Notice of Decision

APPLICATIONS: Project No. PRJ14-00023
File No. AAS16-00005

PROJECT NAME: Riva Townhomes Administrative Adjustment of Circulation
Facilities Standards

REQUEST: Application for an Administrative Adjustment of Standards (AAS)
to substitute the 10-foot wide Primary Through Block Passage
walkway with two 5-foot wide walkways and to reduce the width of
the second walkway from 10 feet to 6 feet

Fig. 1. Detail of Through Block Passages serving interior units.

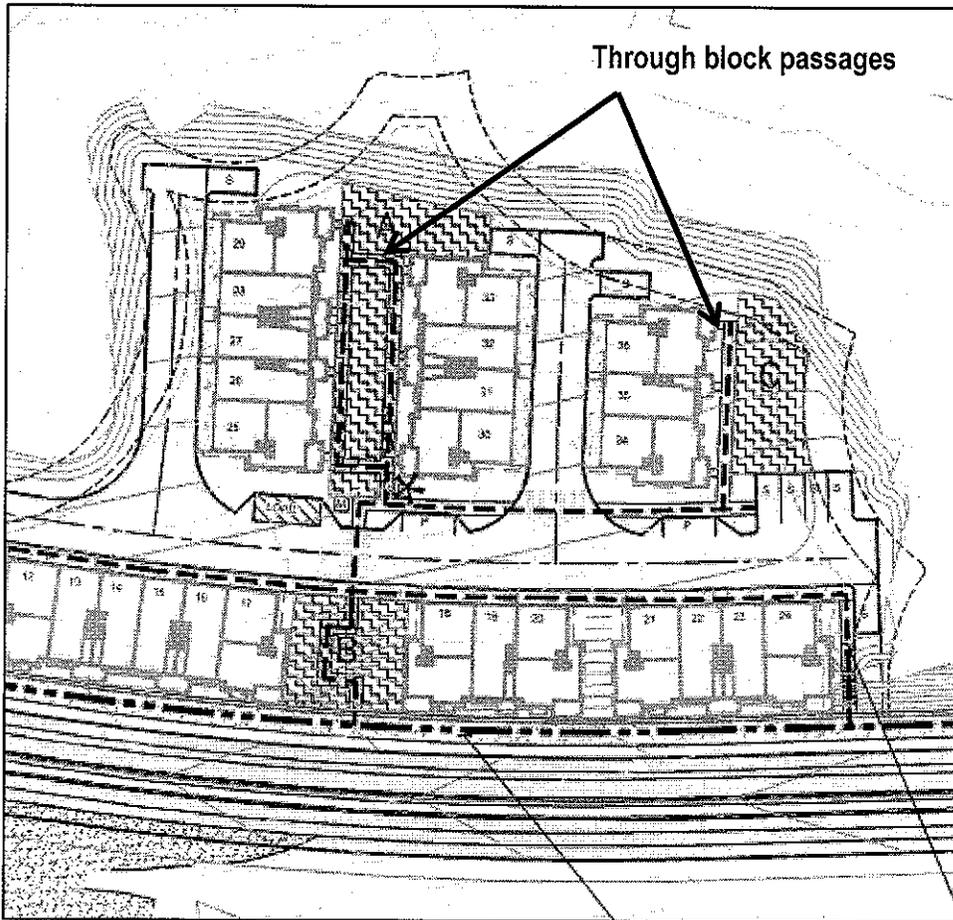
The Primary Through Block Passages are required to serve residential units 25 to 36 that do not have direct access to the main Circulation Facility, Newport Way. CIDDS 14.4.A.5 requires primary building entrances to be accessible and visible from Circulation Facilities. A related standard in Sec. 11.3.M, Residential Front Door Orientation, specifically requires the principal façade to be oriented to a street or a street-facing courtyard. Units 25 to 33 have their principal façades oriented to a courtyard (A).

To comply with Sec. 14.4.A.5, a modified Primary Through Block Passage is provided. Instead of a 10-foot wide paved walkway, two 5-foot wide walkways are provided. The walkways converge into a 10-foot wide walkway that connects to the 10-foot wide sidewalk of Newport Way (see dashed lines in Fig. 1, above, for pedestrian path.) The total width of the Primary Through Block Passage at open space A is 25 feet from building face to building face.

For the Primary Through Block Passage serving units 25 to 33 and open space A

- a. **Vision:** The proposed 6-foot walkways' location is superior in achieving the intent of the Primary Through Block Passage as a gathering space. Flanked by two residential buildings, the walkway would need to be conveniently accessed from the entrances of both buildings. By splitting the walkway into two 6-foot wide walkways within 10 feet of the building entrances, a substantial open space is created between the two buildings, while also providing the shortest walk route for the residents to get to the building entries. If the Primary Through Block Passage standard was followed, the courtyard space would have been cut into two, making the space less useful for recreation.

- b. **Access:** The modified Primary Through Block Passage will not create any significant adverse impacts to abutting properties or rights-of-way.
- c. **Compatibility:** Locating two 6-foot wide walkways within 10 feet of the building entrances is consistent with the residential character of the streetscape throughout the project.

- d. **Sufficient Reason:** The proposed orientation of units 25 -33 was a result of balancing multiple CIDDS design standards applied to the overall site design, including a pedestrian-friendly public realm, the provision of an efficient and intuitive grid circulation system, orienting building facades to major circulation routes, and creating useable open spaces.

- e. Safety: The proposed deviation from the standards will not negatively impact public safety and operation. The landscaping proposed will ensure clear sight lines from Newport Way through the Through Block Passage to the informal play area in open space A, which provides additional informal surveillance of the area. The 6-foot width is a standard width typically used for sidewalks.
- f. Services and Maintenance: The location of the walkways close to the building entrances facilitates quick and direct access for firefighters and emergency service providers.
- g. Priorities: The priorities listed in Sec.6.2.C were not applied to this evaluation because the criteria only apply to auto-inclusive circulation facilities.

Fig. 2. CIDDS 6.4.C Primary Through Block Passage

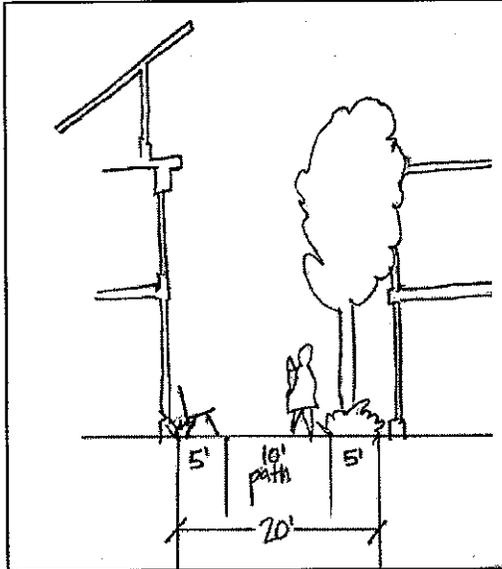
As shown in Fig. 2 below, the CIDDS standard requires a 10-foot wide walkway with 5-foot landscaping on both sides, for a total of 20 feet minimum width for a Through Block Passage.

Fig. 3. Comparison of 6-foot wide and 10-foot wide walkway serving units 34 to 36

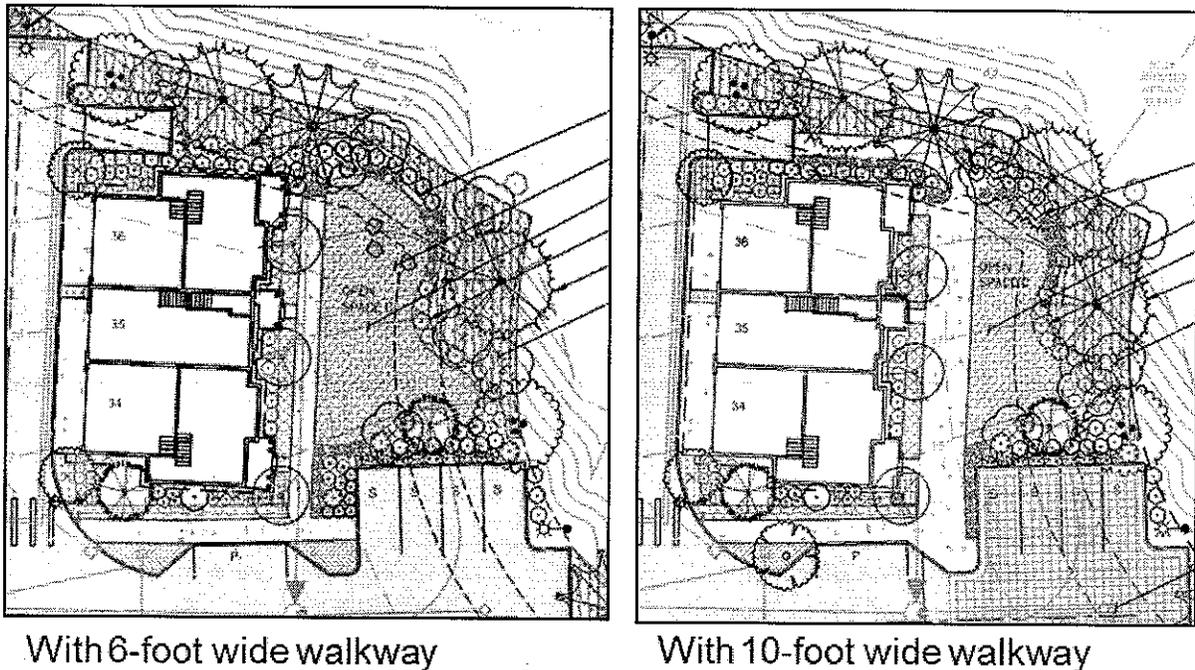
The other Primary Through Block Passage serves units 34 to 36 and a small open space (C). The walkway proposed is only 6 feet wide.

- a. Vision: The proposed 6-foot walkway is superior in achieving the intent of the Primary Through Block Passage as a gathering space. The walkway serves 3 residential units on one side and a small open space C on the other side. Fig. 3 below shows the difference in character of the open space with a 6-foot wide walkway and if a 10-foot wide walkway, as prescribed by the CIDDS, is provided.

The 6-foot wide walkway allows for more useable open space and less impervious area encroachment into the wetland buffer building setback line (shown as the outer dashed line in Fig. 3 below). The east boundary of the open space is constrained by the wetland buffer, so reducing the width of the walkway creates a larger lawn area by expanding the west boundary of the open space.

- b. Access: The modified Primary Through Block Passage will not create any significant adverse impacts to abutting properties or rights-of-way.
- c. Compatibility: The narrower walkway is compatible in scale to the low volume of foot traffic expected with only 3 units being served by this walkway. Furthermore, the 10-foot wide walkway is more appropriate as a circulation spine to a major public open space, which is not provided on the Riva property.

- d. Sufficient Reason: The proposed Through Block Passage was a result of balancing multiple CIDDS design standards applied to the overall site design, including a pedestrian-friendly public realm, highest and best use of land, parking efficiency, protecting critical areas while increasing access through useable open spaces.

- e. Safety: The proposed deviation from the standards will not negatively impact public safety and operation. The orientation of the walkway does not change, and the 6-foot width is a standard width typically used for sidewalks.
